APPENDIX G: NOISE PEER REVIEW

Noise Peer Review – Wilkinson Murray

Re: Noise/Vibration Assessment - Wilpinjong Extension Project - Independent Review

**RE: WILPINJONG EXTENSION PROJECT (SSD 6764) – NOISE PEER
REVIEW – STAGE 1**

Z-Weighted Z-Weighted (Outside equipment Specification) DING

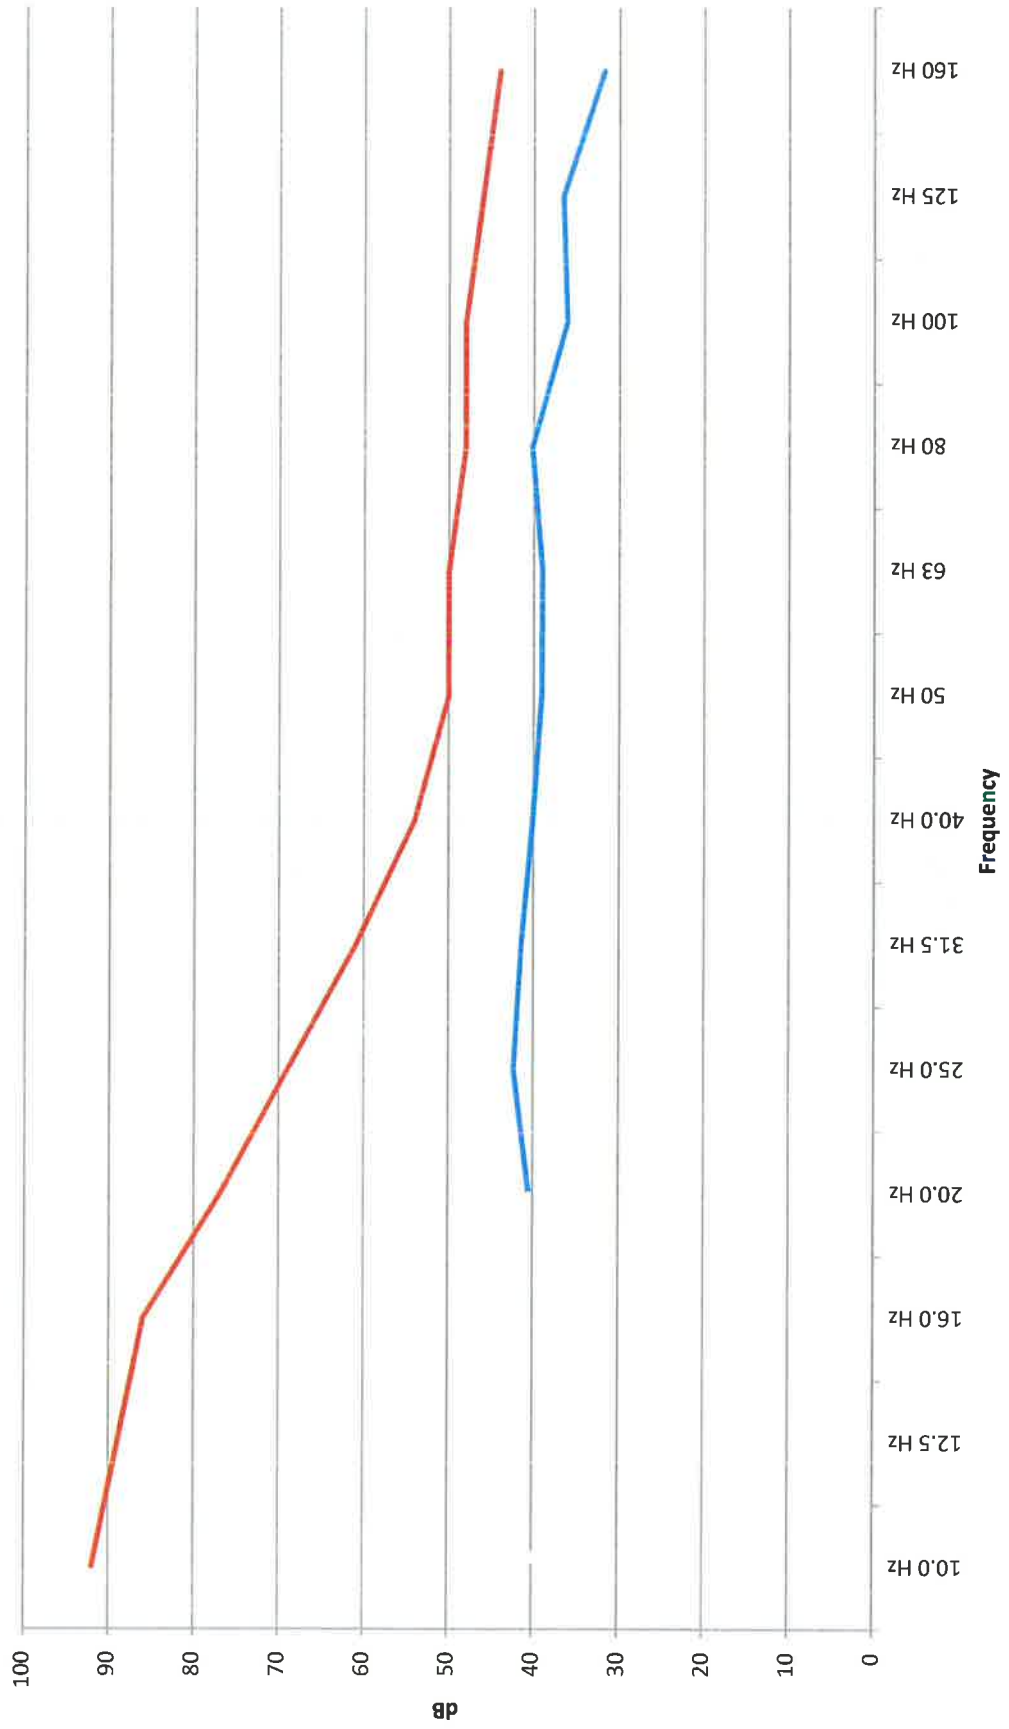
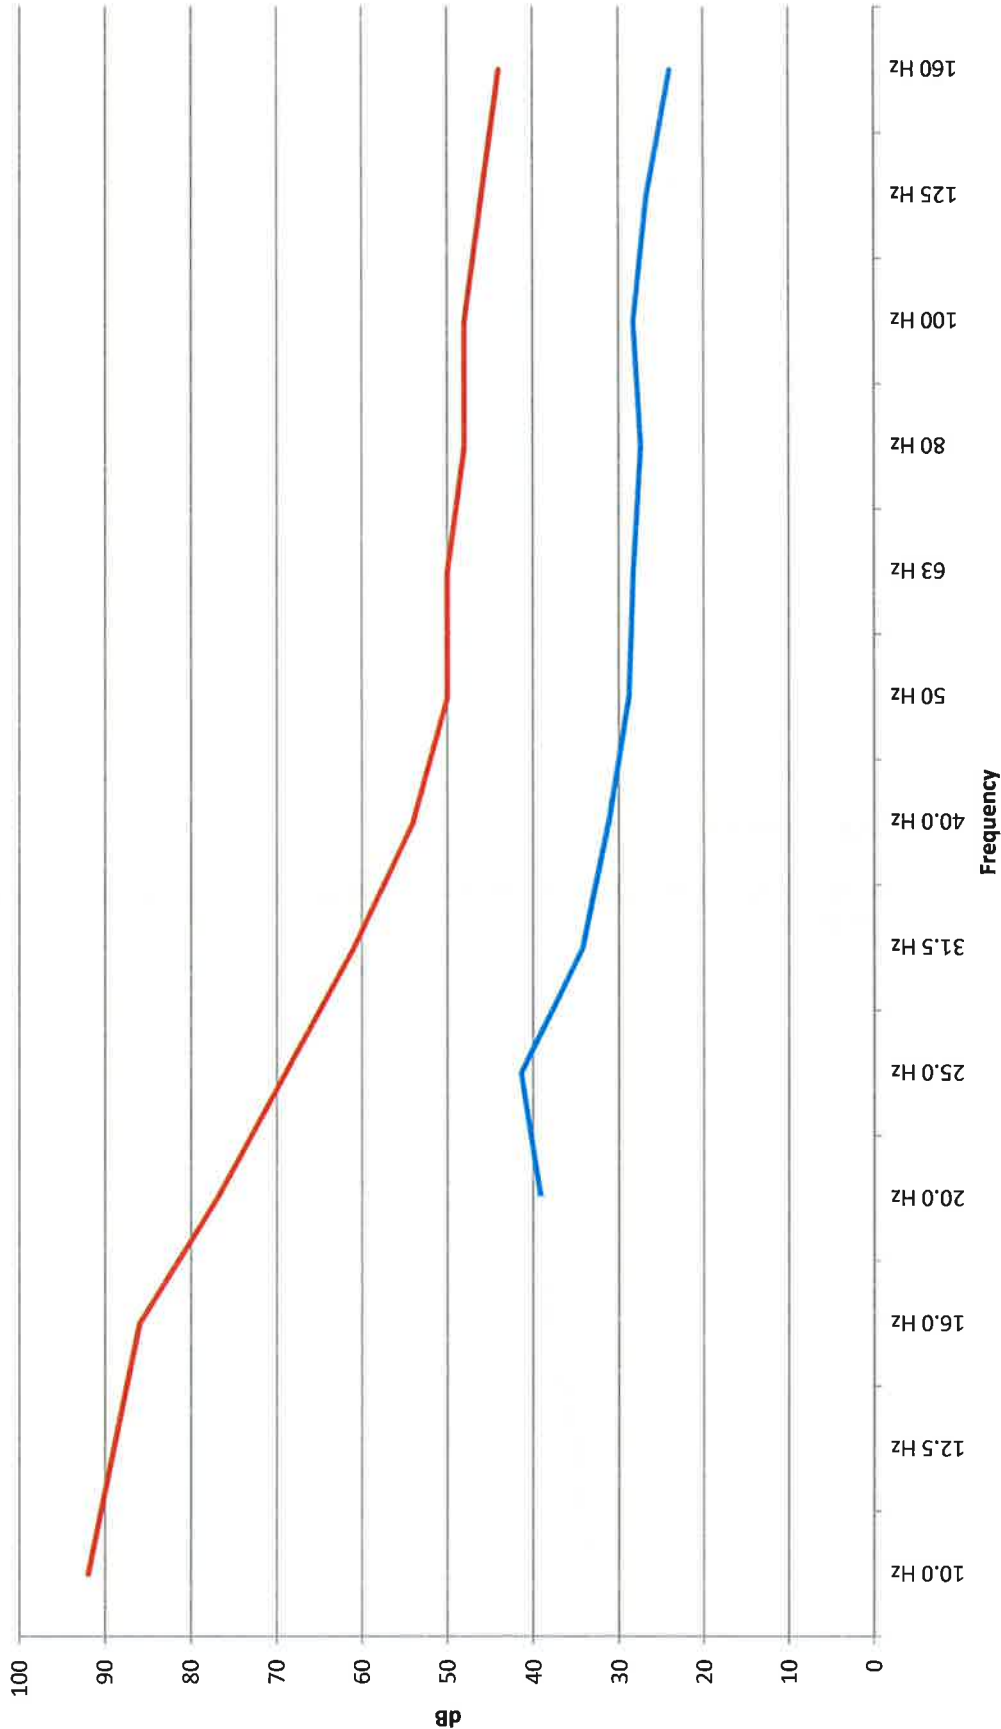
Also attached are graphical outputs of the measured Z weighted noise levels for comparison against the EPA's modified DEFRA criteria (Table C2 of the DING).

The same 147 15 minute individual measurements have been further analysed in accordance with Tables C1 and C2 of the DING. Some 146 (out of the 147) comply with Table C2 of the DING. One individual 15 minute measurement at 1am on 16 December 2012 exceeded the Table C2 1/3 octave band criterion of 46 dBZ (@ 125Hz) by a marginal 1.7 dB. However in this 15 minute period, the overall A weighted noise level was 37.0 dBA and the corresponding overall C weighted noise level was 50.9 dBC (i.e. a difference of 13.9 dB) and therefore this noise level is not assessable for LFN in accordance with Table C1 of the DING.

SLR Consulting conducted an analysis of low frequency noise using the methodology presented in the draft Industrial Noise Guideline. The analysis supported their EIS conclusion that the noise generated by the Wilpinjong Coal Mine does not contain dominant low frequency noise content. Wilkinson Murray concurs with this conclusion.
